Work Order ID 57993

Item Name: Aft Bracket

DART AEROSPACE LTD	Work Order:	57993
Description: Bracket	Part Number:	A4039-3
Inspection Dwg: A4039 Rev: A		Page 1 of 1

From: Harvey Siemens [mailto:hsiemens@dartaero.com]
Sent: April 28, 2010 11:11 AM
To: Mike Petsche
Cc: 'Marc Bellavance'; Jean-Luc Menard
Subject: D4039 Rev. PB1

Figure 3 – D3177-041 Fwd Bracket Attachmen

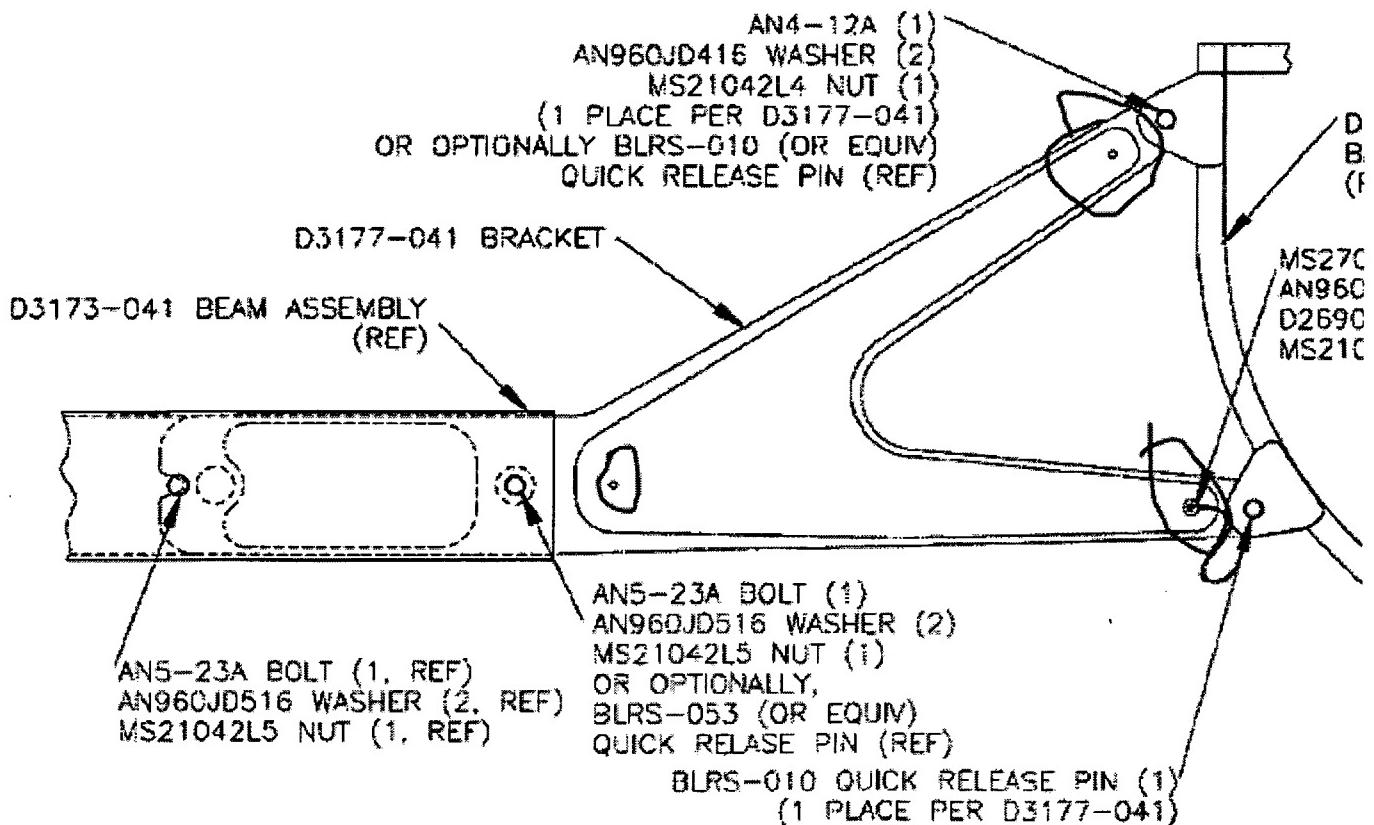
Holes circled in red. New dwg says dia: 0.191. Old dwg has the them at 0.203

This is an acceptable deviation.

D4039-041 FWD BRACKET ASSEMBLYD4039-043 AFT BRACKET ASSEMBLY

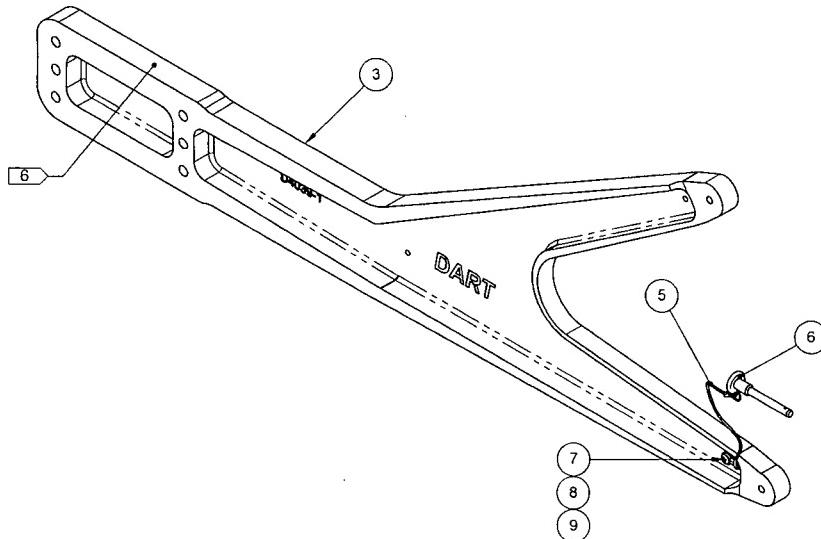
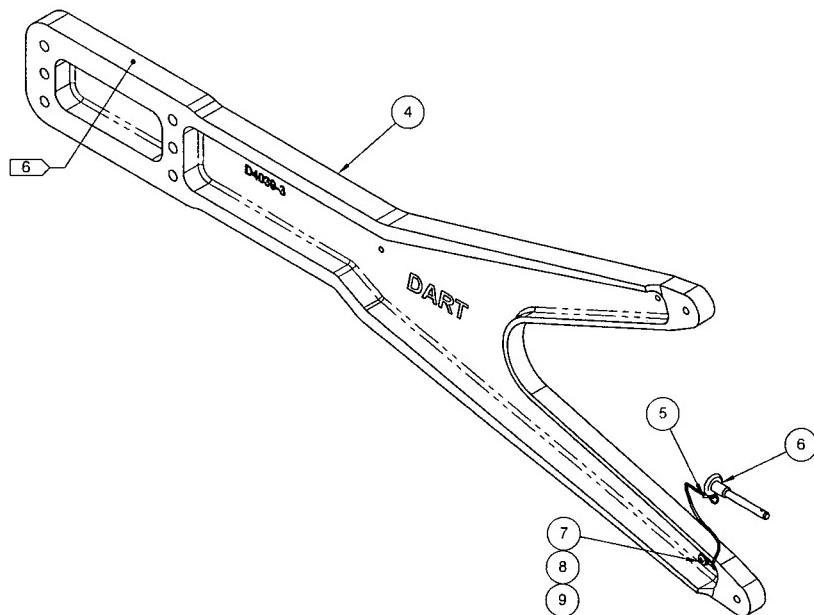
Talked with JL this morning and he raised an inconsistency between the D4039-1 and the -3 regarding the hole

sizes. This discrepancy has been corrected. Since you were the original reviewers, I am forwarding the prelim drawing to you. Thank you for your time in going over the attached drawing. Let me know if there are any other details that need to be changed or adjusted.

PB1	REVISE HOLE SIZE ON D4039-3 FROM 0.191 TO 0.203, ZN B6-3		10.04.28
A	NEW ISSUE	HS	09.12.14
REV.	DESCRIPTION	BY	DATE
DESIGN		DART AEROSPACE LTD	
DRAWN		HAWKSLEY, ONTARIO, CANADA	
CHECKED		DRAWING NO.	REV. PB1
MFG. APPR.		D4039	SHEET 1 OF 3
APPROVED		TITLE	SCALE
DE APPR.		BRACKET	NTS
DATE	10.04.28	COPYRIGHT © 2009 BY DART AEROSPACE LTD THIS DOCUMENT IS PRIVATE AND CONFIDENTIAL AND IS SUPPLIED ON THE EXPRESS CONDITION THAT IT IS NOT TO BE USED FOR ANY PURPOSE OR COPIED OR COMMUNICATED TO ANY OTHER PERSON WITHOUT WRITTEN PERMISSION FROM DART AEROSPACE LTD.

D4039-1 FWD BRACKET

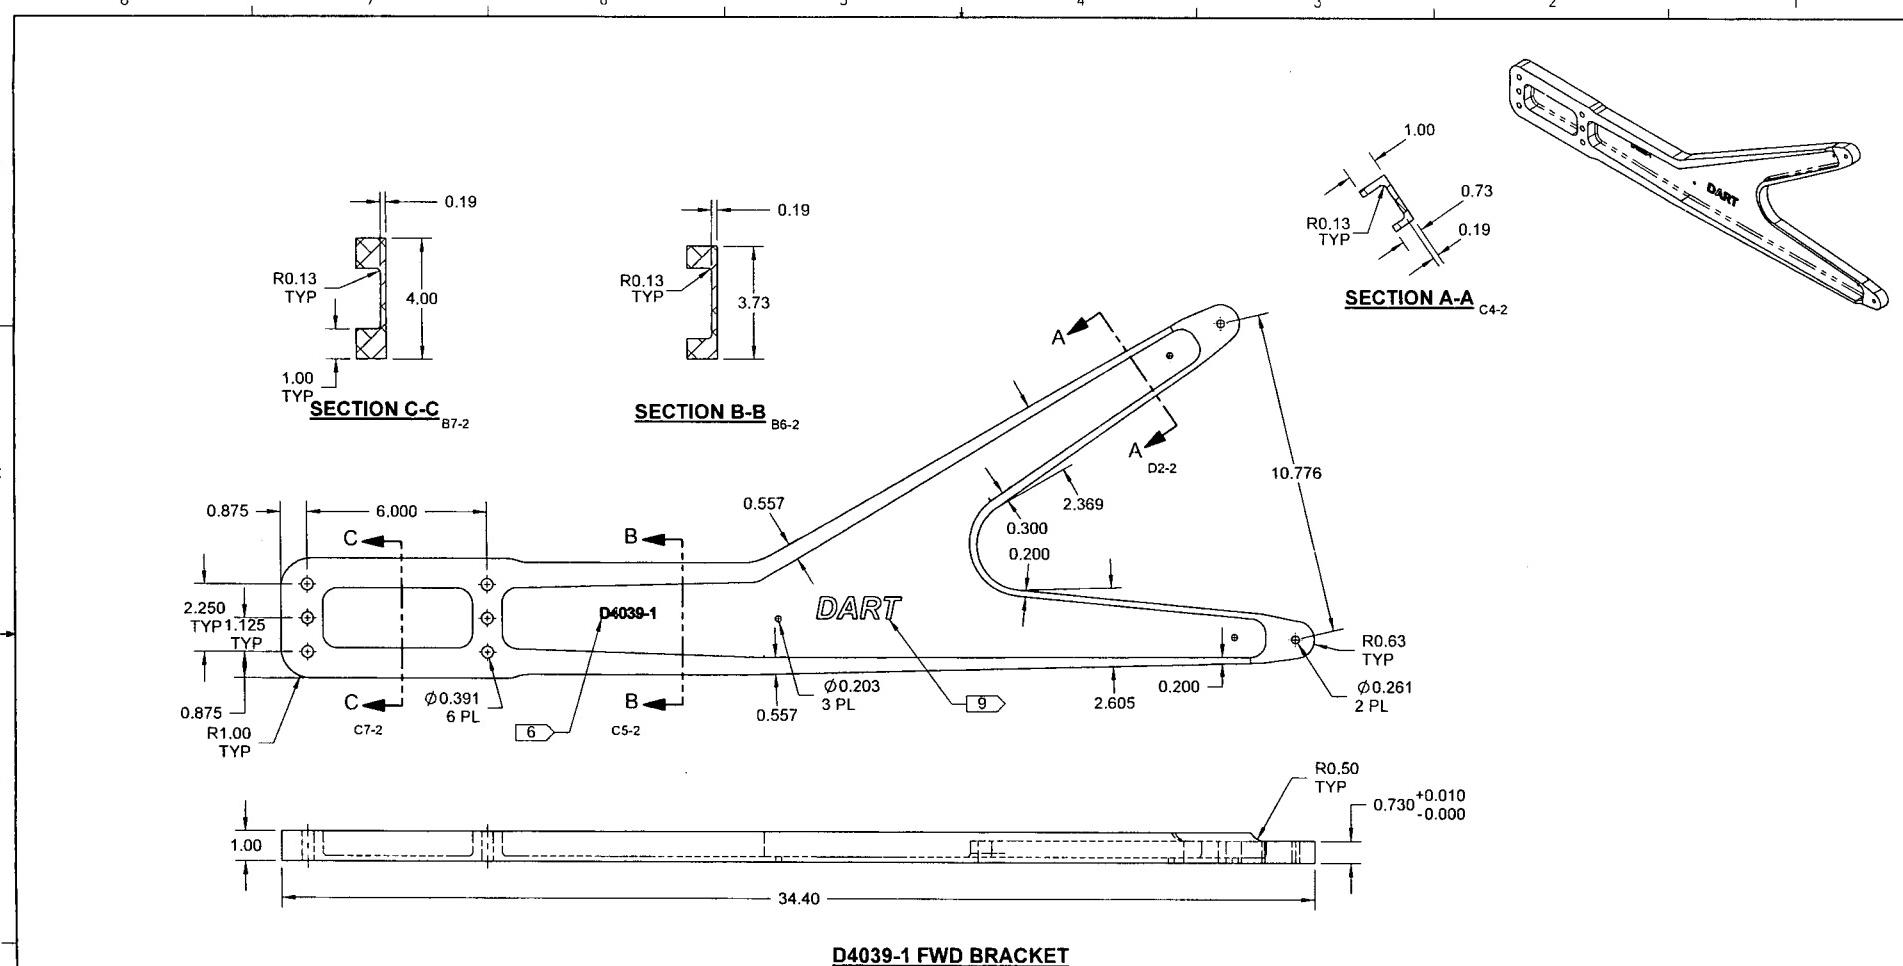
Thought about Section A-A and D-D and the 0.73 dimension that is shown there vs the 0.730 +0.010/-0.000 dimension shown in zone B3. The B3 dimension is for the lug at the end while the section view dimension is just for that shorter leg of the beam. I think the way we have it dimensioned is correct. We want to maintain a tight tolerance on the lug but the shorter leg portion is not so critical. Let me know if that explanation doesn't make sense.
